ADDENDUM NO. 3

COMMUNITY PARK ELEMENTARY SCHOOL

Issued: January 30, 2026

FVHD PROJECT NO. 5516C

Drawing Number
A104

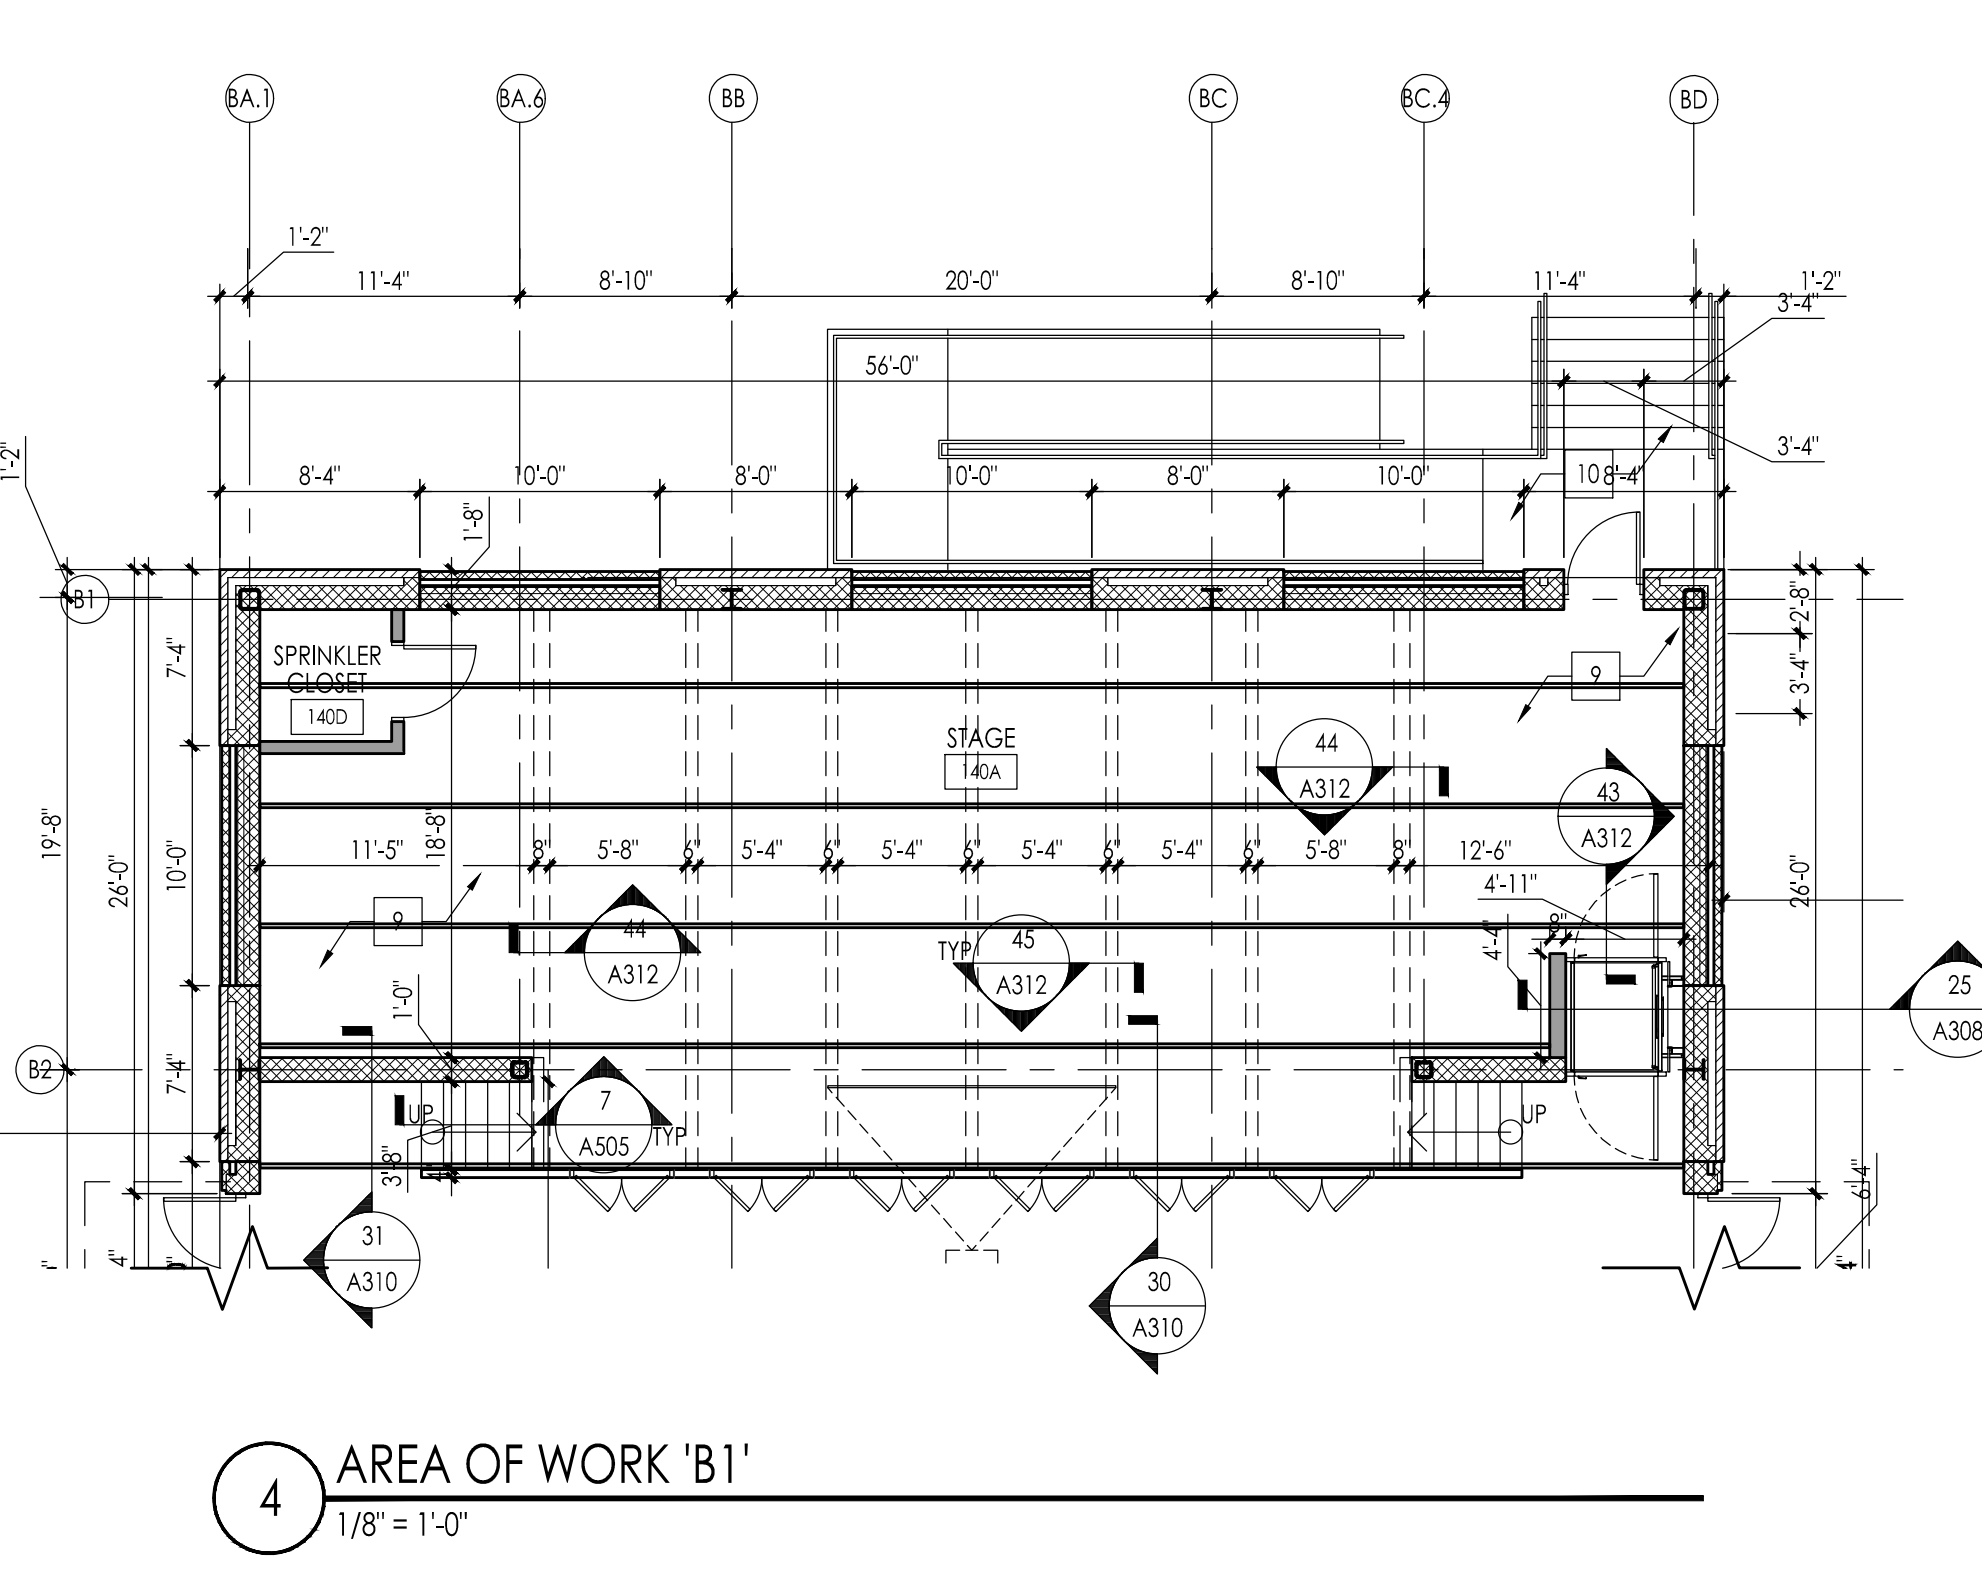
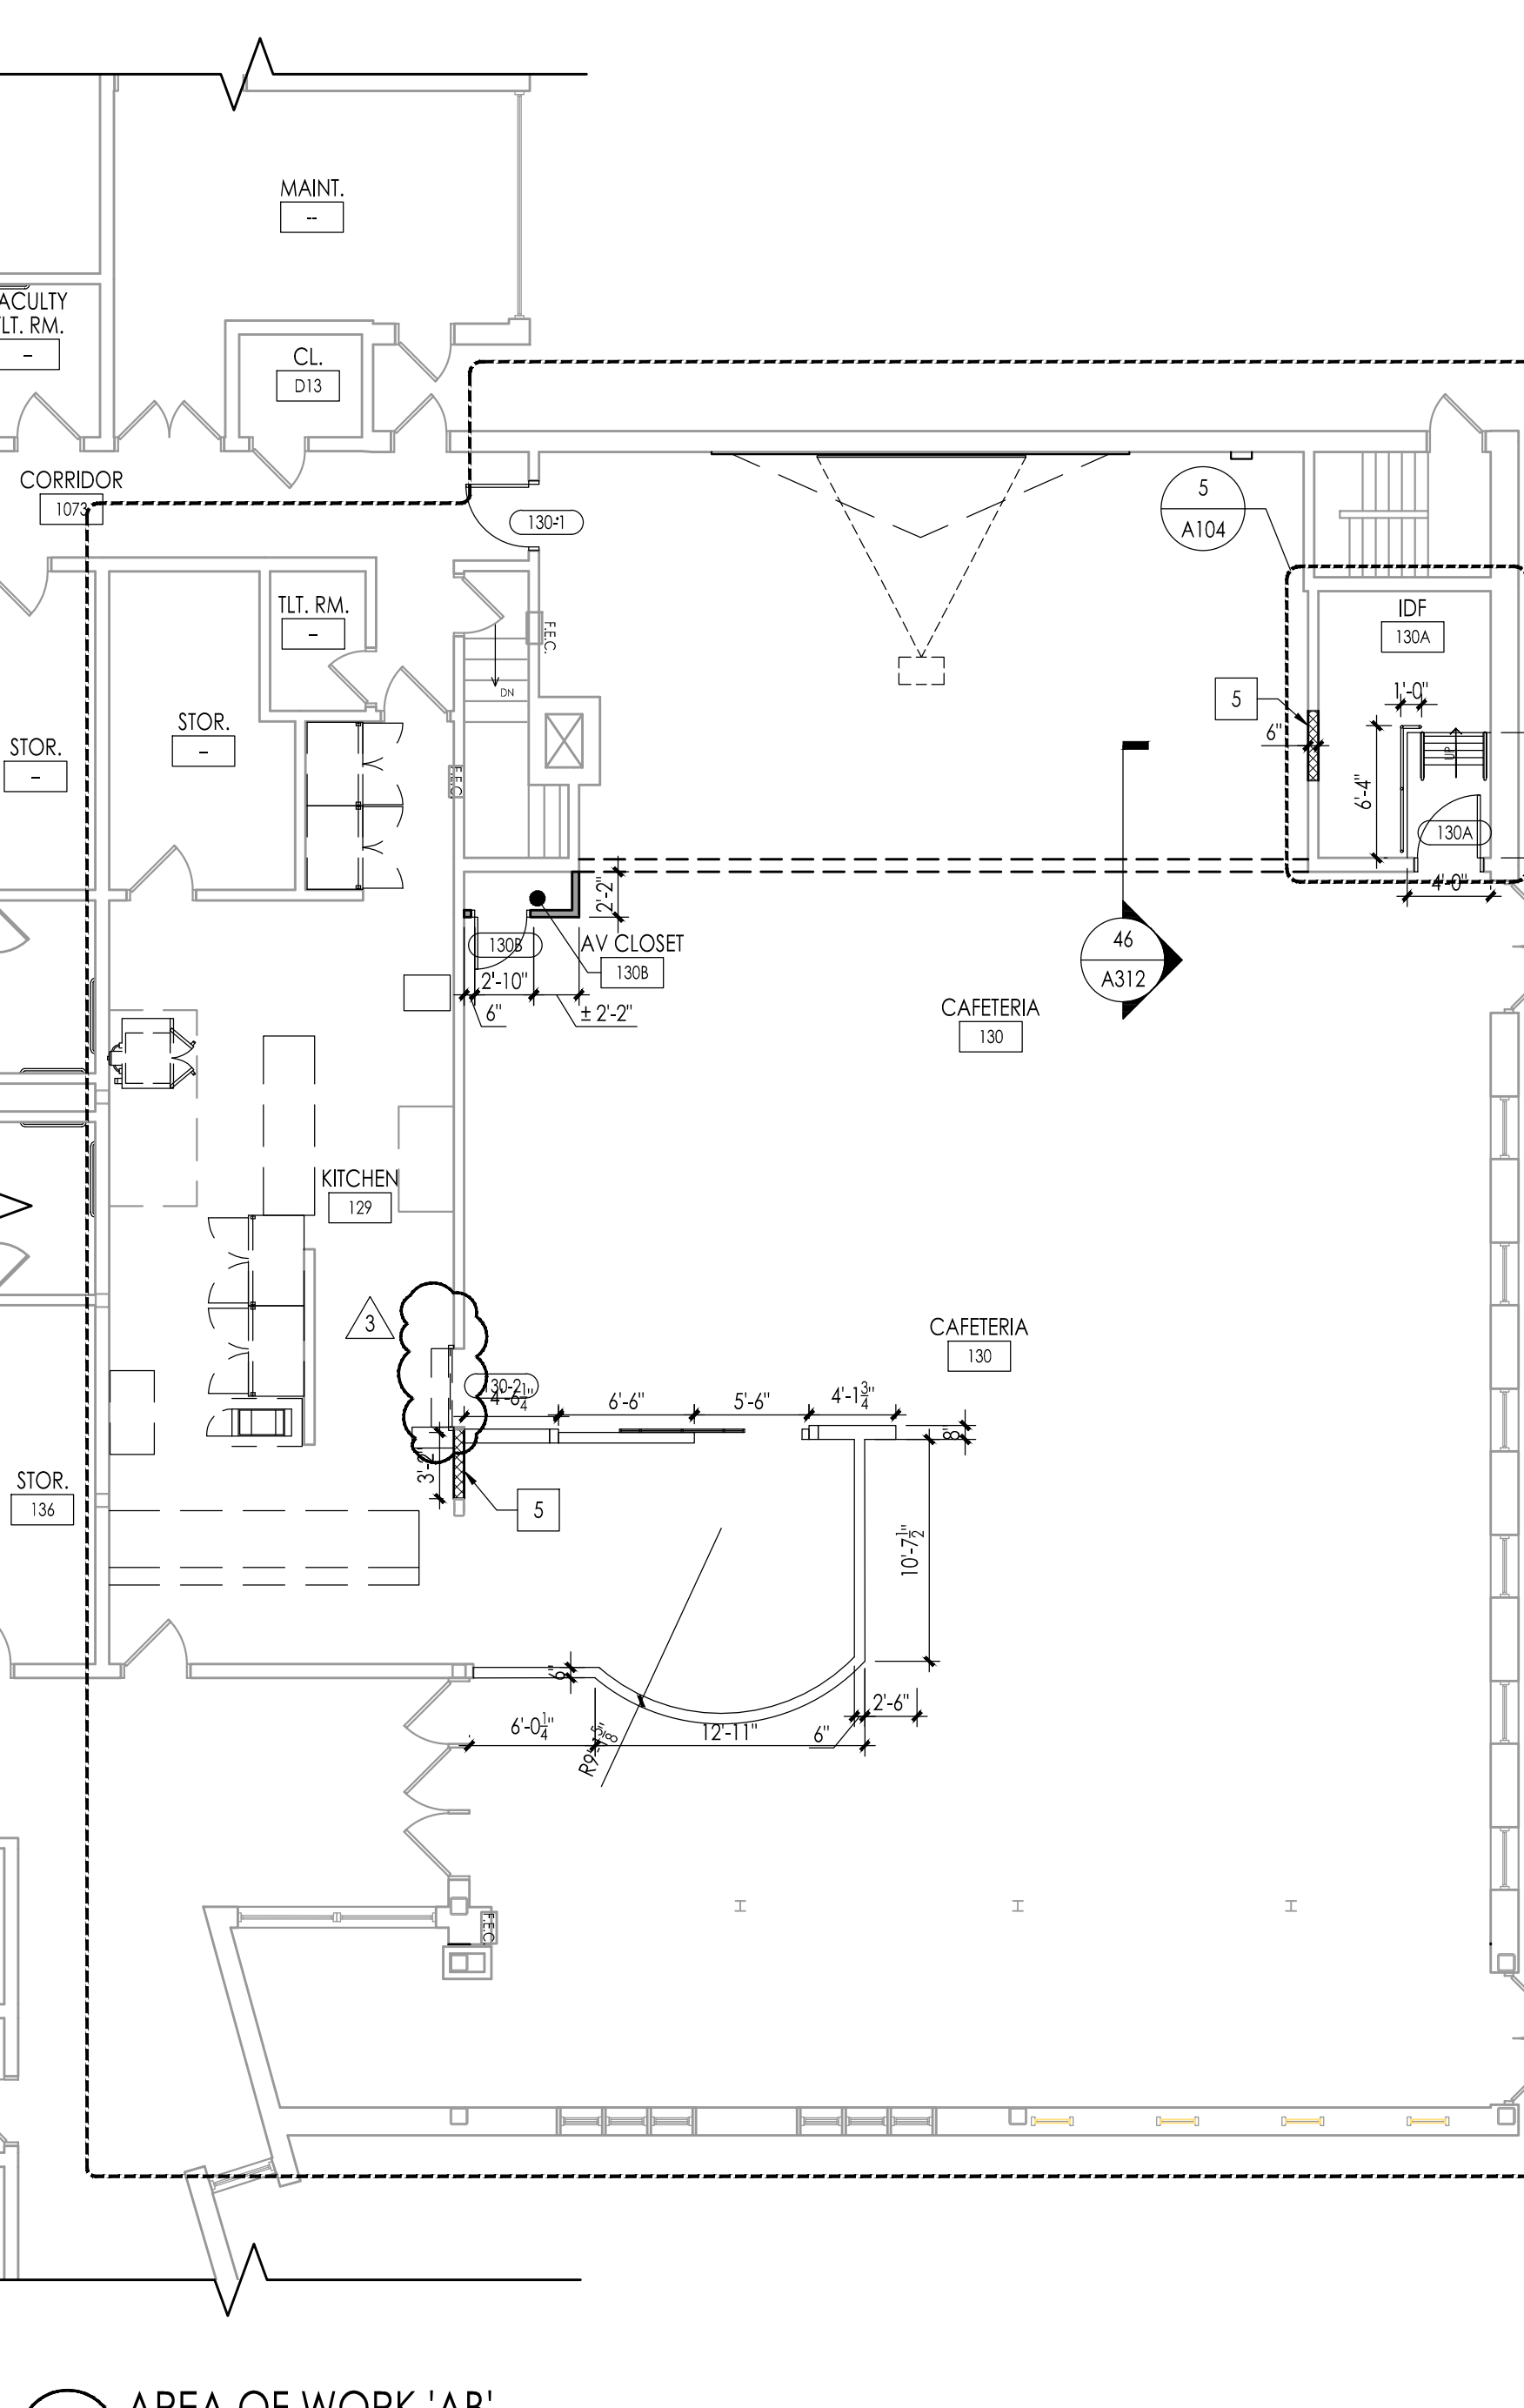
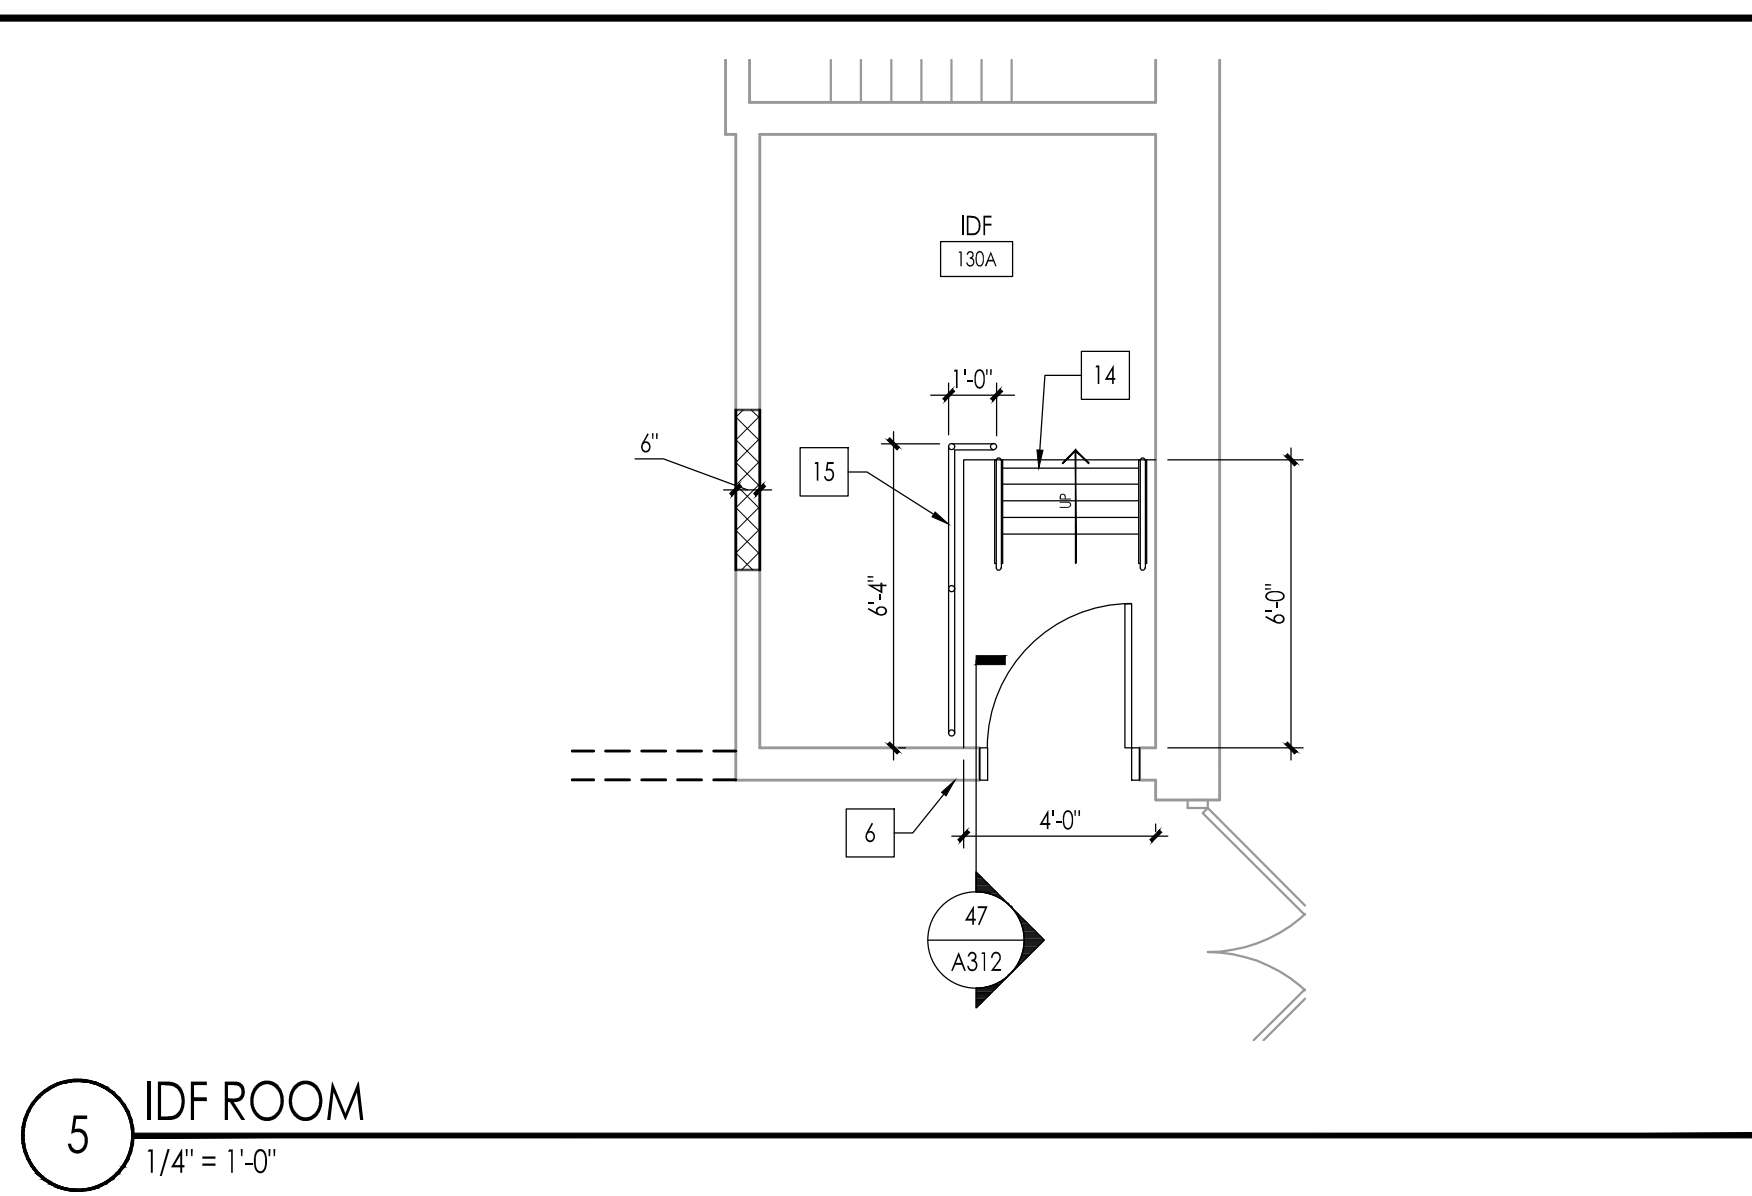
1. Question: Spec Section 08340 for Overhead Coiling Grille Door but nothing on drawing. Confirm this section is not needed

Response: See revised A104, A407 and A601 for location and details related to the Overhead coiling grille.
